Responses to Sierra Club Data Requests: Nos. 1 through 97

Amended Application for Certification for HYDROGEN ENERGY CALIFORNIA (08-AFC-8A) Kern County, California

**RESPONSES TO DATA REQUESTS 1 THROUGH 97
FROM SIERRA CLUB**

FIGURE 84-1

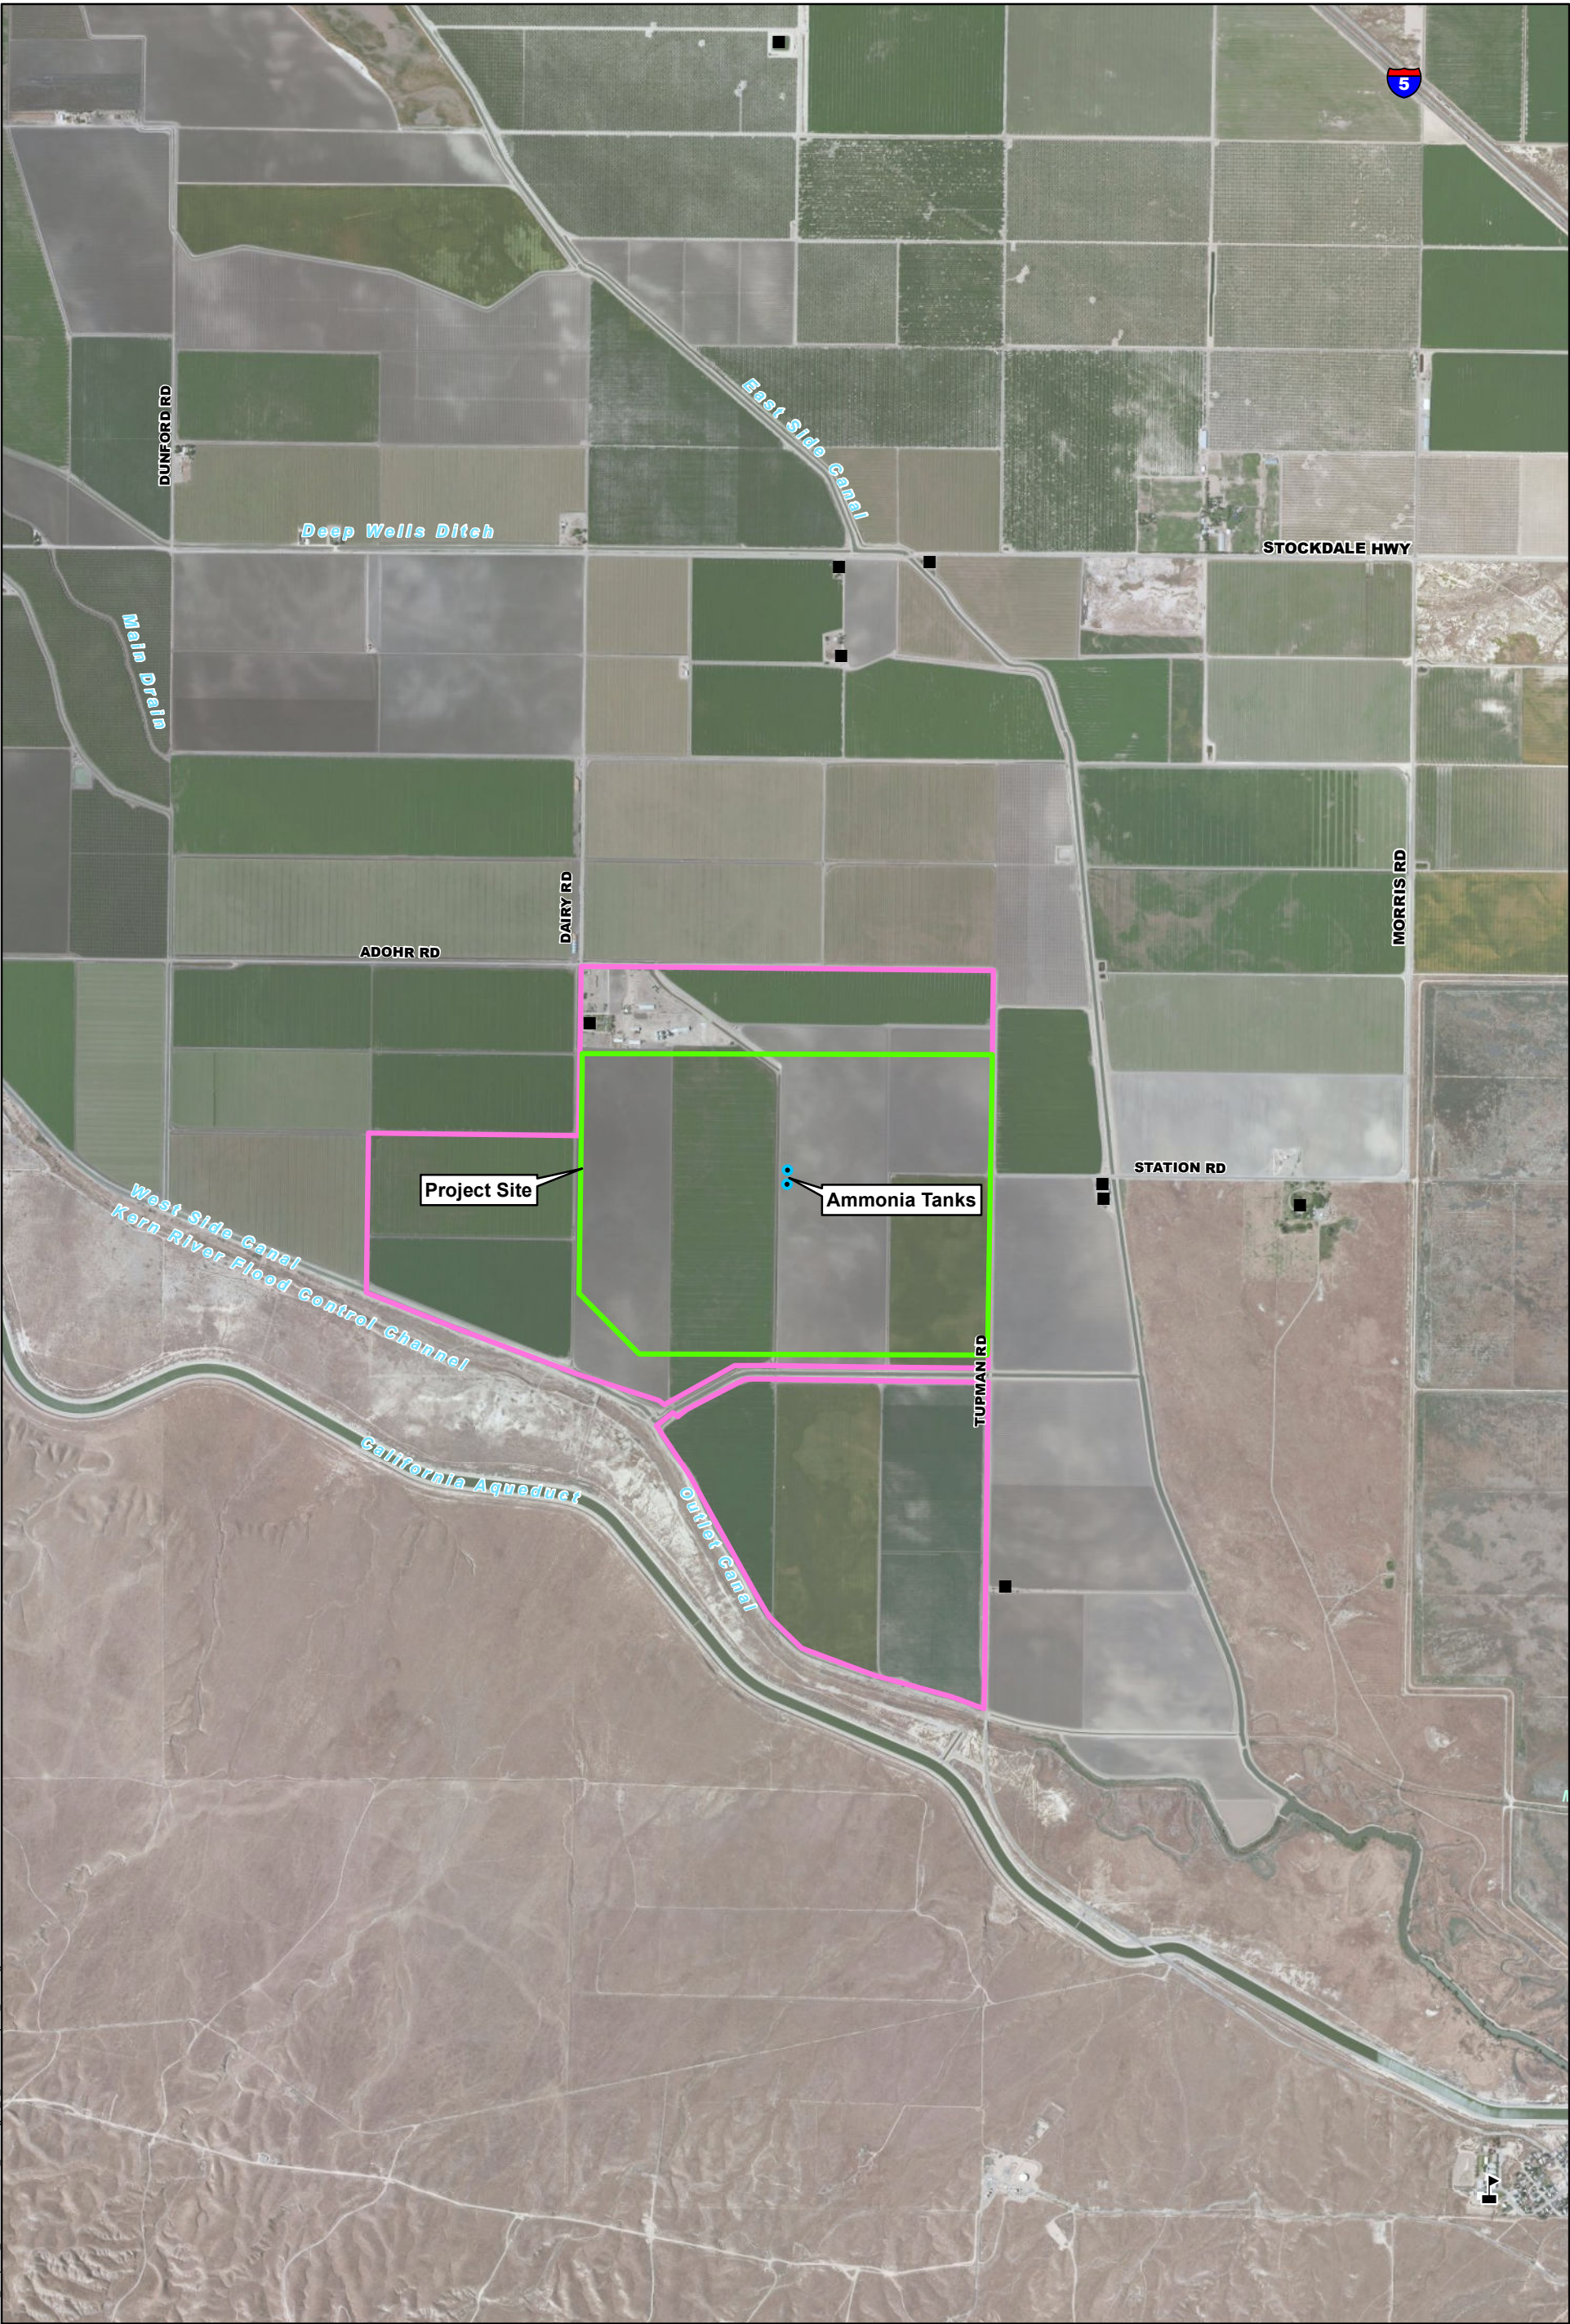
84. The AFC provides an off-site consequence analysis for the potential catastrophic failure of the entire 3.8 million gallons of aqueous ammonia in the storage tanks.

- a) Please provide the input/output files for the ALOHA 5.4 air dispersion modeling.**
- b) The AFC refers to "model results in Figure L-1, Aqueous Ammonia Area of Potential Impact from Worst-Case Scenario" but fails to provide this figure. (AFC, Appx. K, p. K-19.)**
- c) Please provide a copy of Figure L-1. Please discuss why the dispersion analysis does not account for prevailing wind direction. (See AFC, Appx. K, p. K-19.)**

- a. The input and output information for the ALOHA 5.4.1 dispersion model was included in the 2012 Amended AFC, Appendix K, Section 3.3.1.
- b. The 2012 Amended AFC, Appendix K, erroneously referred to Figure K-1 and Figure L-1, "Aqueous Ammonia Area of Potential Impact From a Worst-Case Scenario." The current project as described in the 2012 Amended AFC will store anhydrous ammonia, and will not store aqueous ammonia, as did the project described in the 2009 Revised AFC.
- c. Figure 84-1, Anhydrous Ammonia Area of Potential Impact From a Worst-Case Scenario, is provided with this response.
